THE NATIONAL BOARD
OF BOILER AND PRESSURE VESSEL INSPECTORS

NATIONAL BOARD INSPECTION CODE COMMITTEE

MAIN SESSION MINUTES

Meeting of July 17th, 2024
Louisville, KY

FIGURE S3.5.6-d

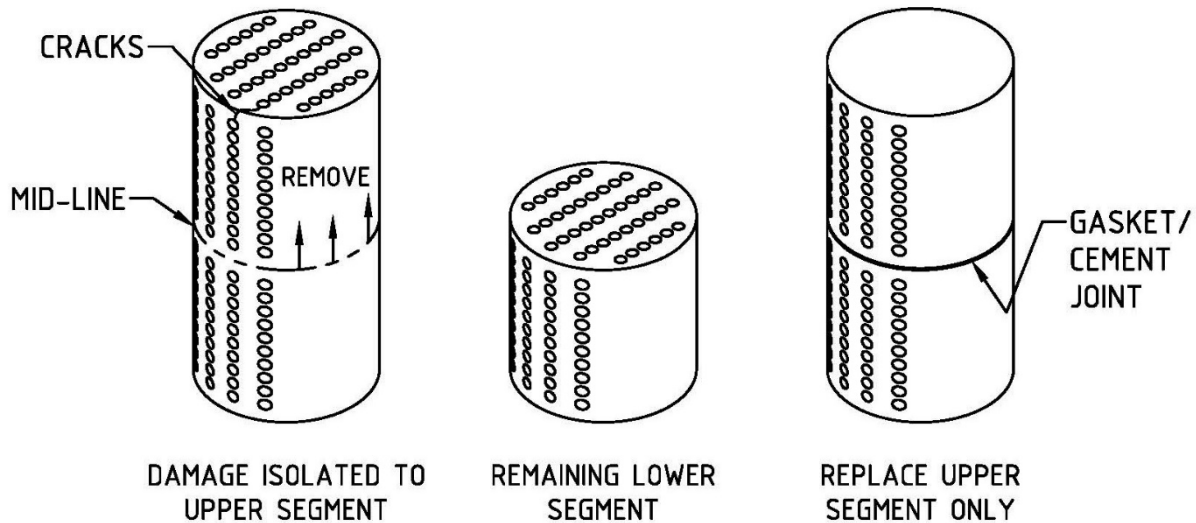
- e) When a modular multi-block type of cross-drilled block is confirmed to be transferring fluid, is showing visible ligament cracking, or has visible surface erosion damage, it shall be tested as required according into S3.5.6-a. Once the location of all the damage is identified, if a single Ssegment is determined to be free of damage, that segment may be re-used after cutting away the damaged affected segment(s). The portion of the block that was removed shall be replaced.

FIGURE SX.1
DECISION TREE (LOGIC DIAGRAM) FOR DETERMINING REPAIR OR ALTERATION ACTIVITY CLASSIFICATION
BASED ON PART 3, SECTION 3, 3.4.4, ALTERATION EXAMPLES

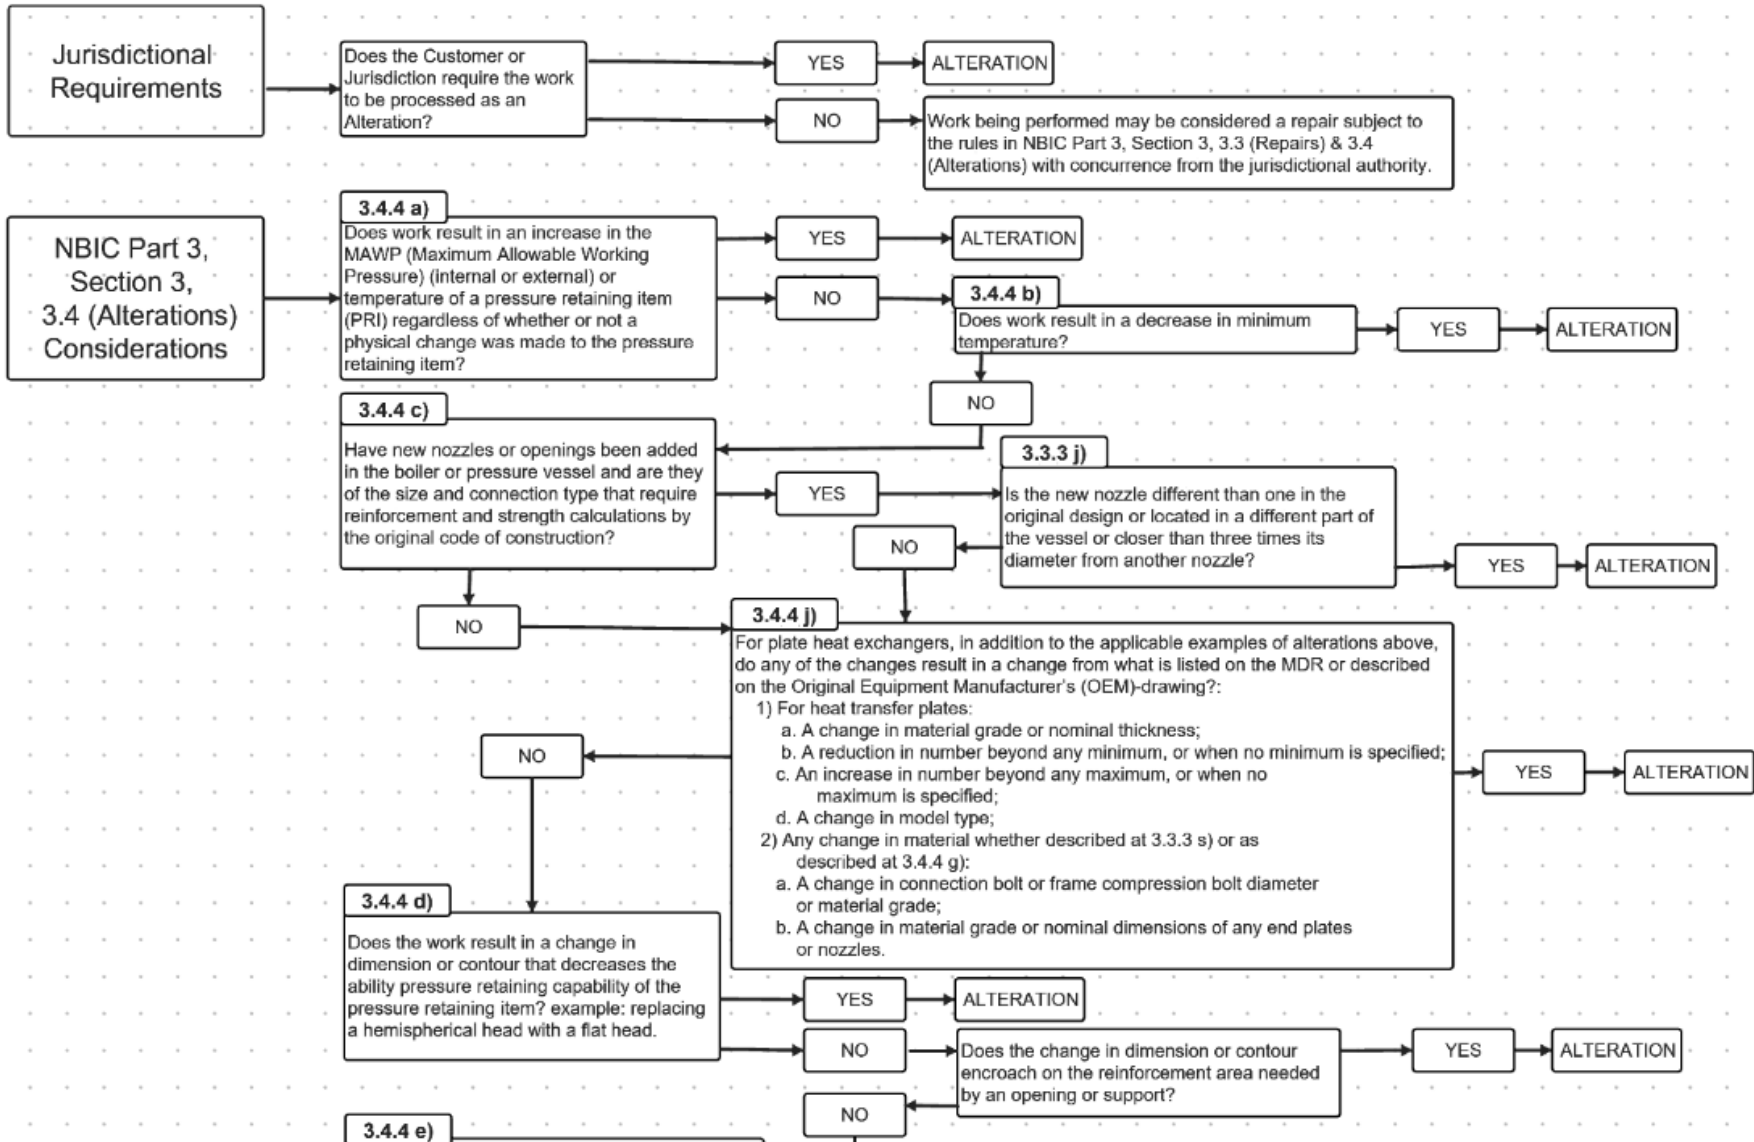
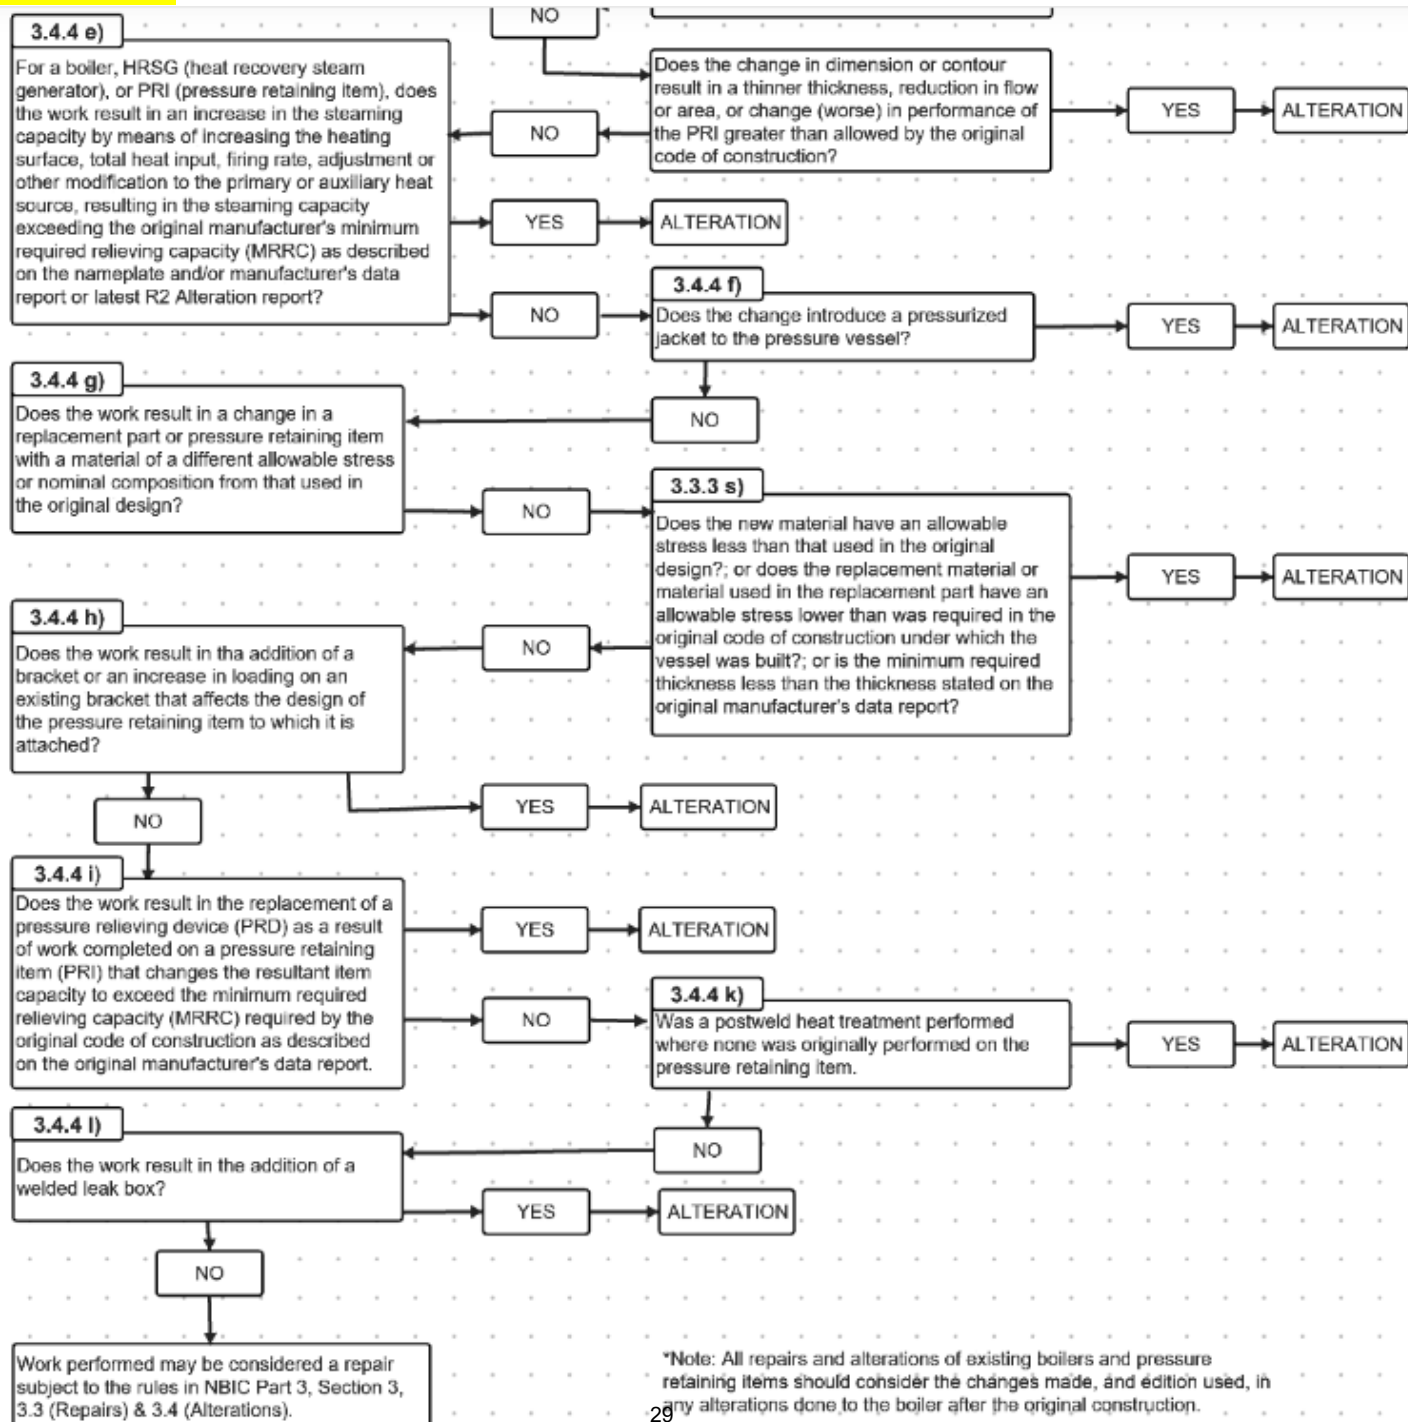
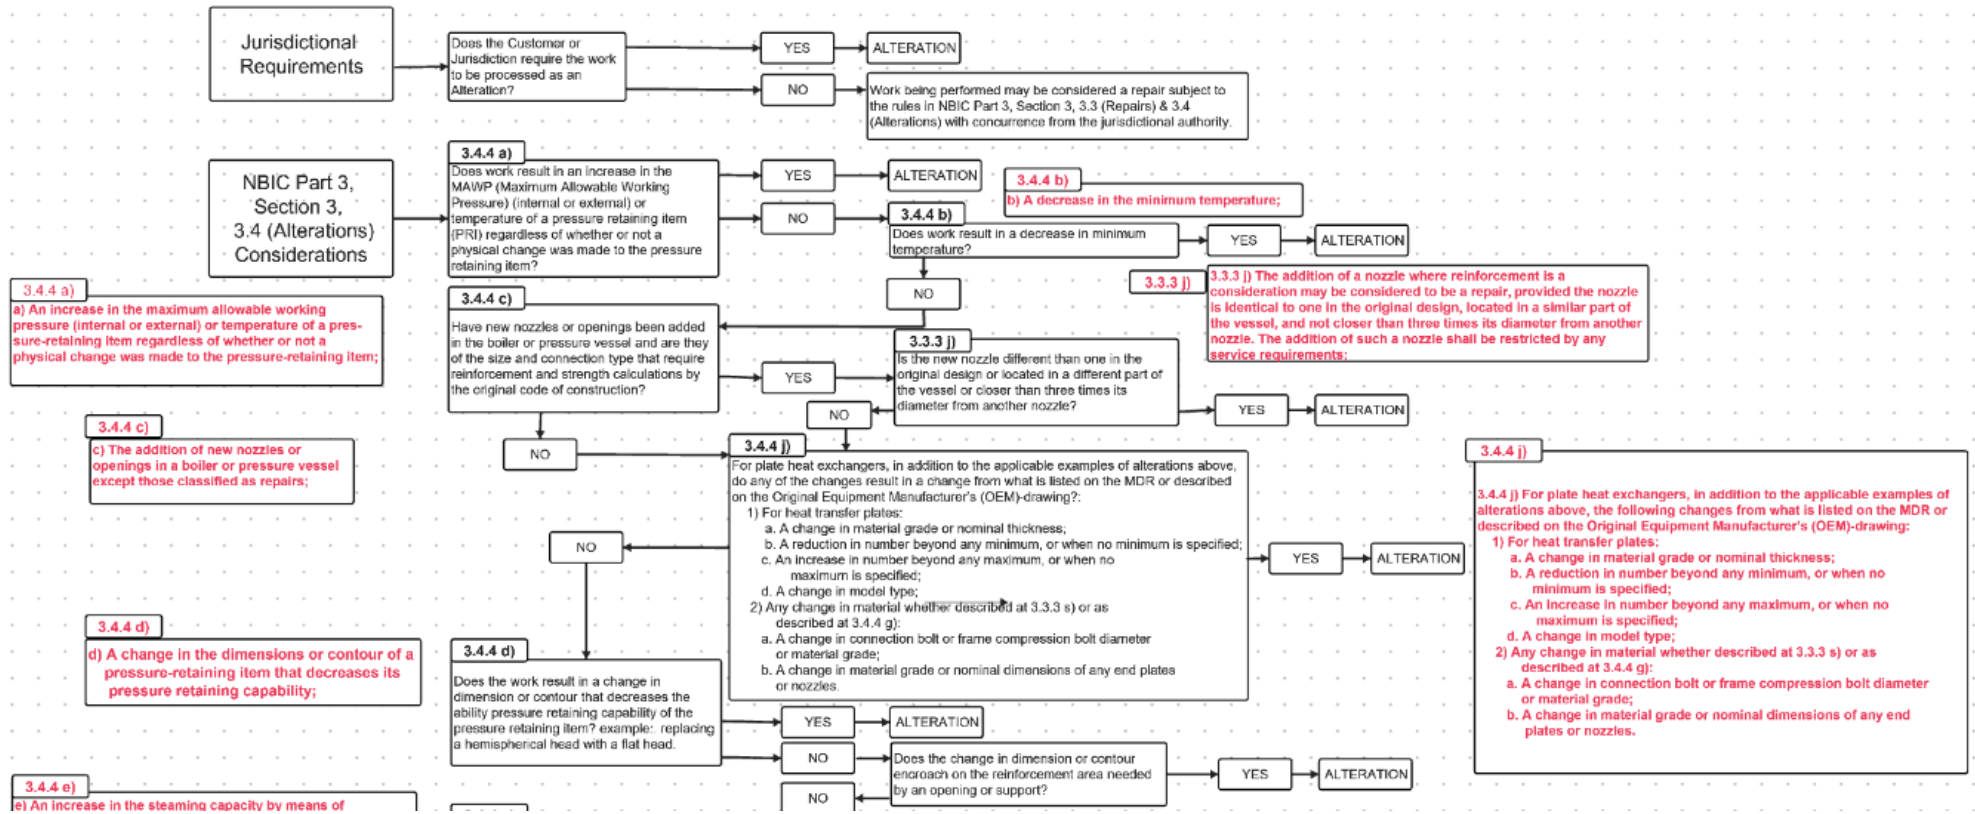
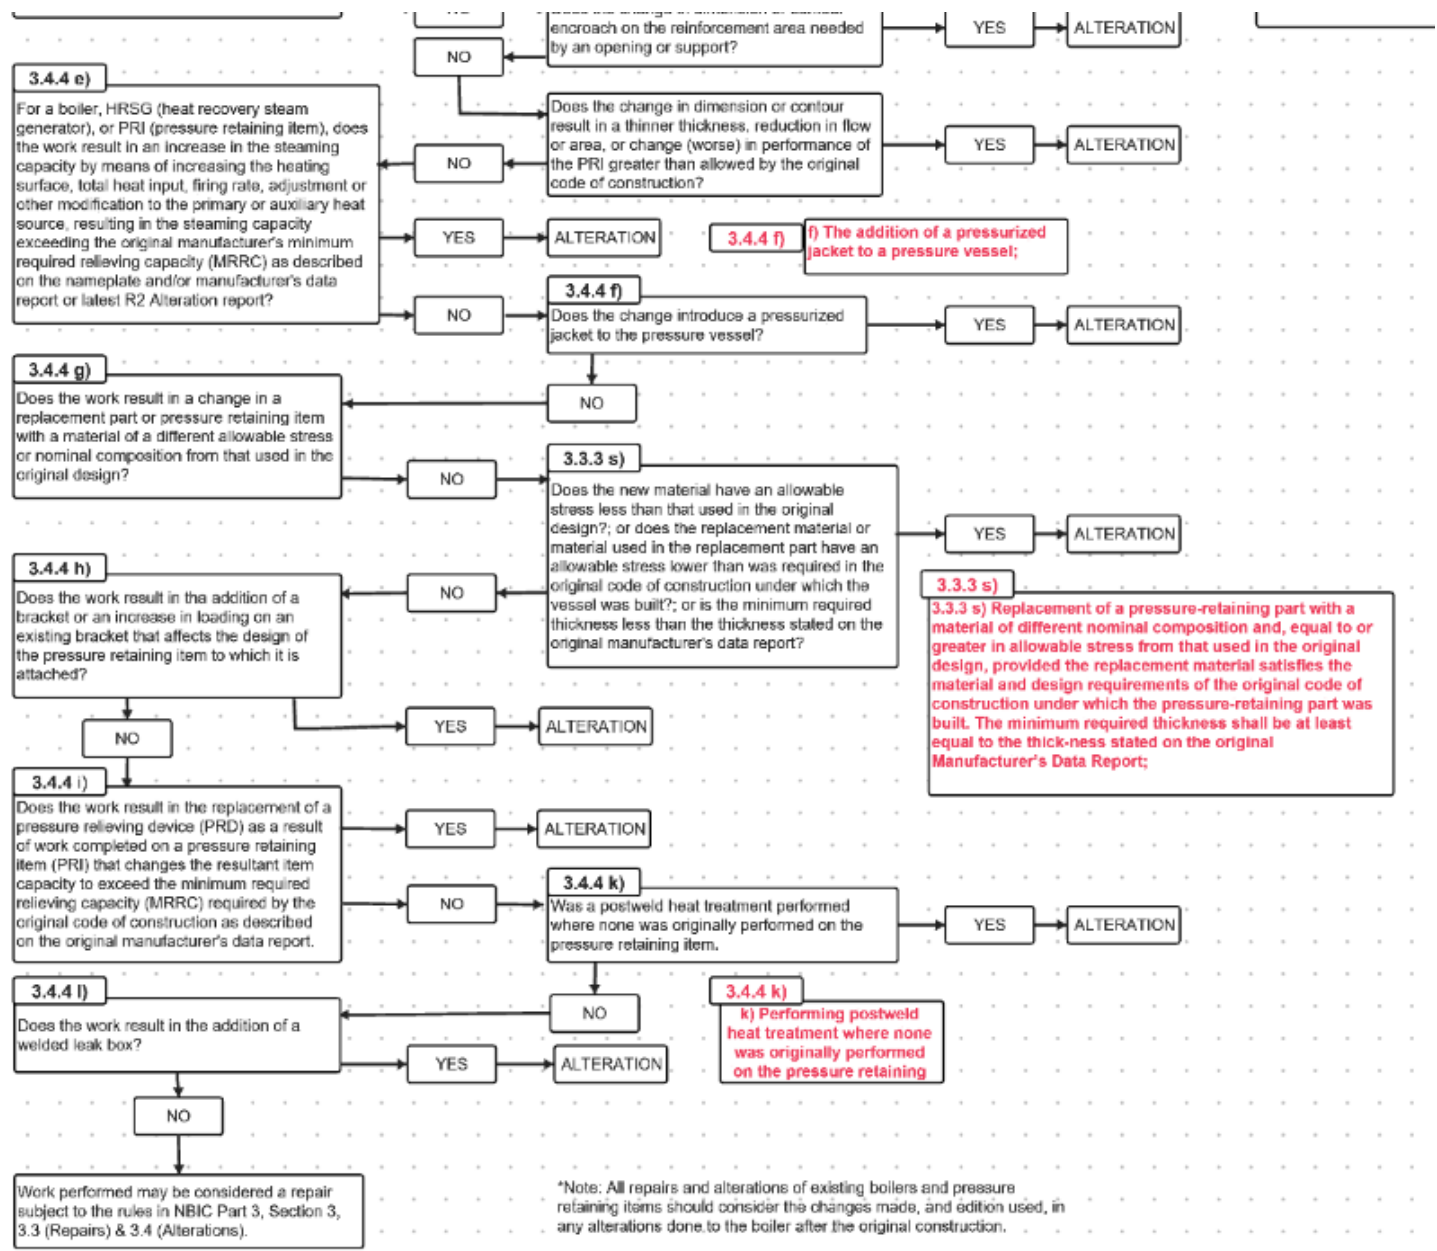
Item Number: 21-12	NBIC Location: Part 3, 3.3.3, 3.4.4, Section 9	Attachment Page 26
General Description: Clarify the definitions and examples of "Repair" and "Alteration"		
Subgroup: Repairs and Alterations		
Task Group: P. Becker (PM), K. Moore, P. Shanks, R. Underwood, T. Seime		
Explanation of Need: Clarify the definitions of "Repair" and "Alteration" in the Glossary and revise the list of examples of each to better define the allowable scope of activities.		
History: This Item was created as a result of conversation regarding Interp. Item 20-78 and Action Item 20-54		
July 2024 Meeting Action: Ms. Pat Becker spoke on the proposal for this item. She stated that the goal of this proposal is to improve user experience when deciding between repairs and alterations. A motion was made and seconded to approve the proposal as presented. A vote was taken, and the motion was approved with one disapproval vote. The reasons given for the disapproval vote were:

<ol style="list-style-type: none">1. There was insufficient time given during the meeting to review the changes to make sure that a substantive change had not accidentally been made during creation of the flow chart.2. "MAWP (maximum allowable working pressure)" should be "maximum allowable working pressure (MAWP)"

FIGURE S8.3-b.

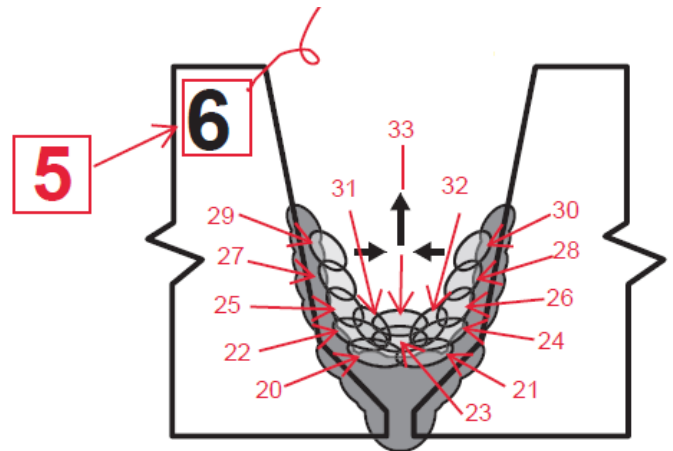
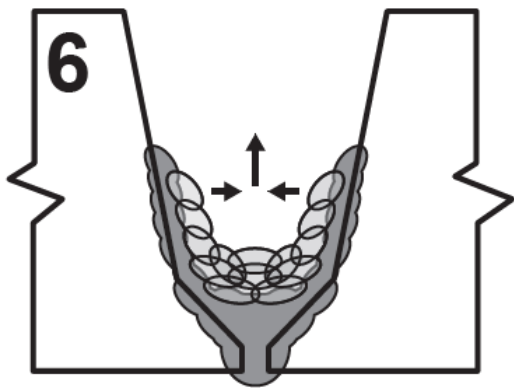
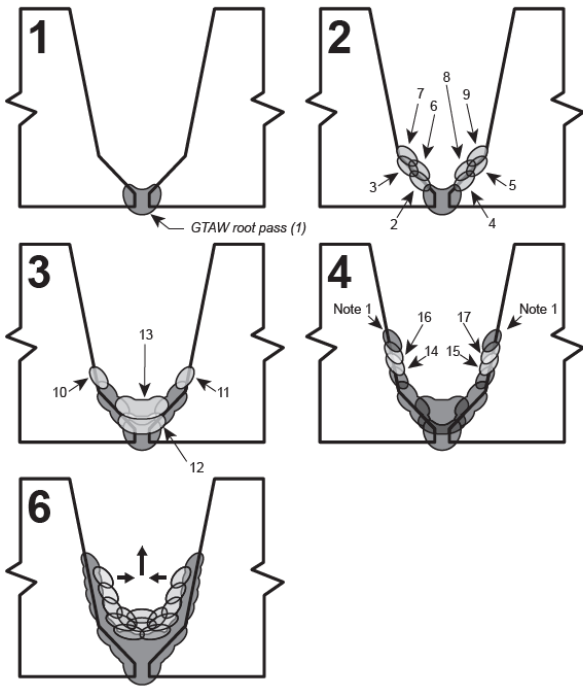
Explanation of Need: Add 'Step 5' to FIGURE S8.3-b. (currently missing). Remove references to 'B9' and 'B87' weld filler metal including Notes A, B, and C in Table S8.2.1

Note 1 – Where the excavation may pose challenges with electrode access, it is recommended that the fill passes in immediate contact with the machined excavation be restricted in height as the weld repair is performed.

FIGURE [SXX.2.1-a](#)

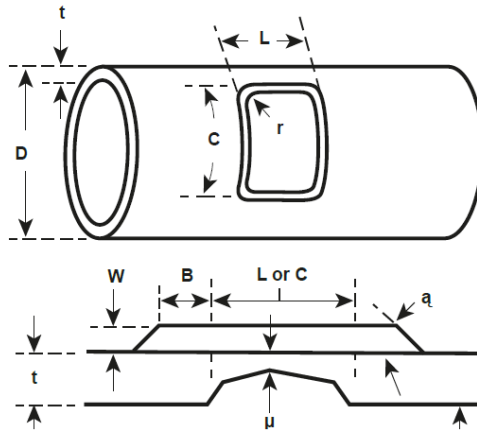
<p>3.3.4.3 WASTED AREAS</p> <p>e) External Weld Metal Buildup</p> <p><i>All text in 3.3.4.3(e), including Figure 3.3.4.3-c, will be relocated to paragraph SXX.2.1 of the new Engineered Repairs and Alteration Supplement as indicated on page 2 of this proposal.</i></p>
<p>3.3.4.8 REPAIR OF PRESSURE-RETAINING ITEMS WITHOUT COMPLETE REMOVAL OF DEFECTS</p> <p><i>All text in 3.3.4.8 will be relocated to paragraph SXX.2.2 of the new Engineered Repairs and Alteration Supplement as indicated on page 2 of this proposal.</i></p>
<p>3.3.5 REPAIR OF ASME SECTION VIII< DIVISION 2 OR 3, PRESSURE VESSELS</p> <p><i>All text in 3.3.5 will be relocated to paragraph SXX.2.3 of the new Engineered Repairs and Alteration Supplement as indicated on page 2 of this proposal.</i></p>
<p>3.4.3 ENCAPSULATION</p> <p><i>All text in 3.4.3 will be relocated to paragraph SXX.3.1 of the new Engineered Repairs and Alteration Supplement as indicated on page 2 of this proposal.</i></p>

FIGURE 3.7.5.1-c
HOT-WATER BOILERS IN BATTERY — ACCEPTABLE PIPING INSTALLATION

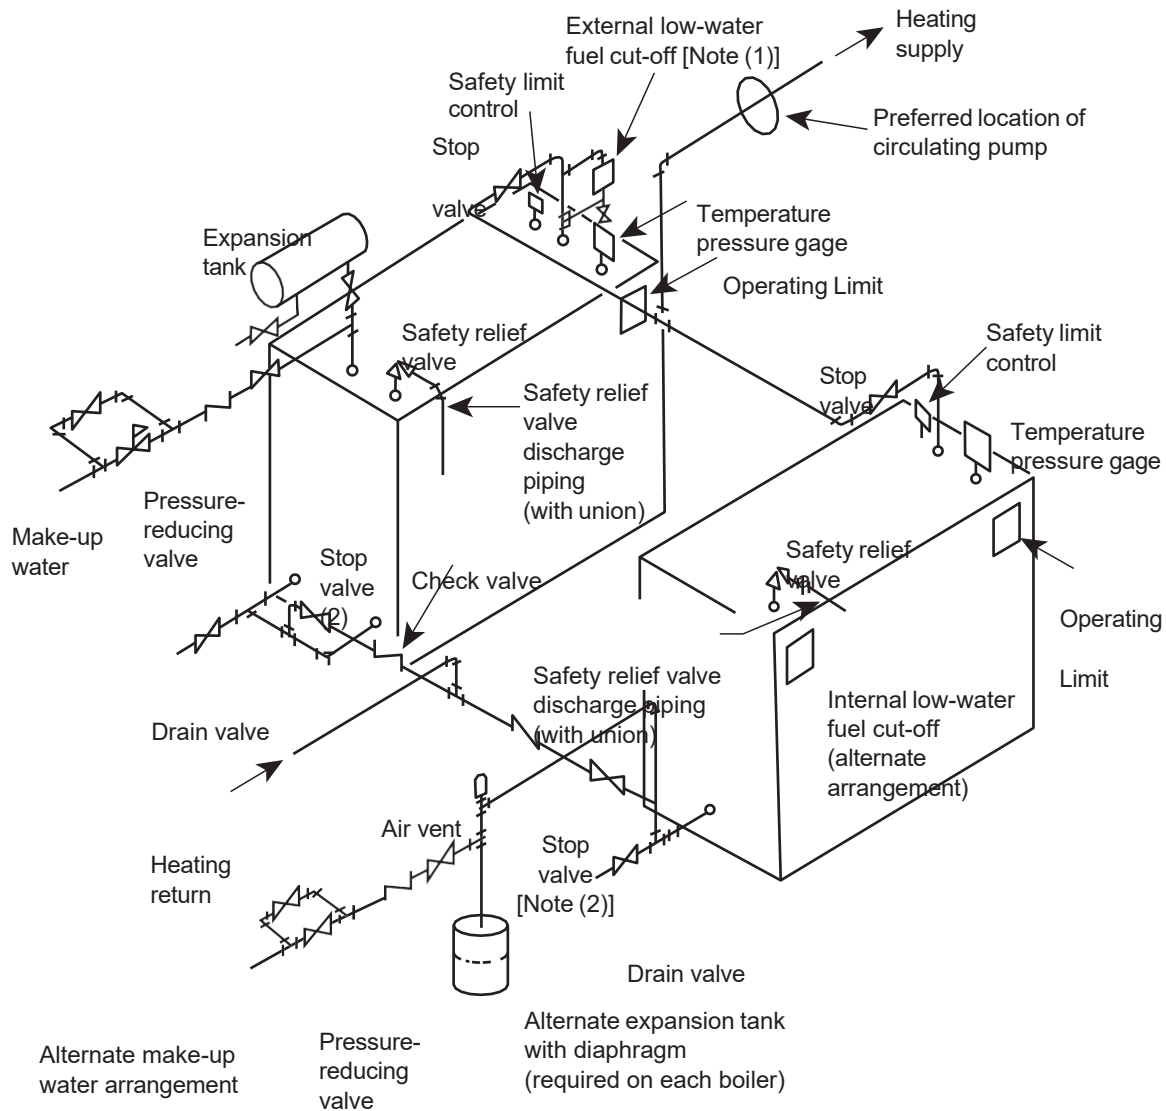
Explanation of Need: Please review and revise to clarify what Note 1 is trying to communicate. Consider rewriting the third sentence to be more specific.

Item Number: 24-30	NBIC Location: Part 1, Figure 3.7.5.1-c	Attachment Page 81
<p>General Description: Revise Note 1 in Part 1, Figure 3.7.5.1-c for clarity</p> <p>Subgroup: SG Installation</p> <p>Task Group: R. Adams (PM)</p> <p>Explanation of Need: This is being submitted on Gary Scribner's behalf: Please review and revise to clarify what Note 1 is trying to communicate. Consider rewriting the third sentence to be more specific.</p> <p>July 2024 Meeting Action: Mr. Tom Clark presented the proposal for this item. A motion was made, seconded, and unanimously approved to accept the proposal.</p>
